Access Audit Site Report

Brazos Bend State Park
21901 Farm to Market Rd 762
Needville, TX 77461
Accessibility Evaluation
Inspection Date: 06/14/2021
Inspectors: Tanya Scheibe

**AMERICANS WITH DISABILITIES ACT COMPLIANCE INITIATIVE
PROGRAM AND POLICY REPORT
JULY 28, 2023**

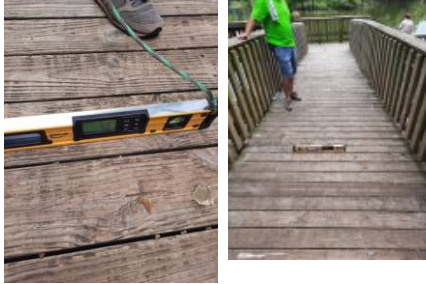
Finding Number	Area Description	Lat/Long	Finding	As Built	Recommendation	Citation	Photos	Figure
356	Hale Lake Area: Hale Lake Restrooms	[29.3757115 , -95.5831835]	There are not enough accessible toilet compartments. The room contains several toilet compartments. A minimum of 1 must be wheelchair accessible .	Men's restroom - ambulatory only	Create a wheelchair accessible stall with grab bars and fixtures mounted in correct locations and at correct heights	2015 ABAAS Section: F213.3.1 2012 TAS Section: 213.3.1 2010 ADAS Section: 213.3.1		
357	Hale Lake Area: Hale Lake Restrooms	[29.3757243 , -95.5831728]	The ambulatory stall is not between 35" to 37" wide and 60" deep.	Stall lacks required dimensions to be an ambulatory stall - 38.5" wide	Correct ambulatory stall to be 35" to 37" wide and minimum 60" deep	2015 ABAAS Section: 604.8.2.1 2012 TAS Section: 604.8.2.1 2010 ADAS Section: 604.8.2.1
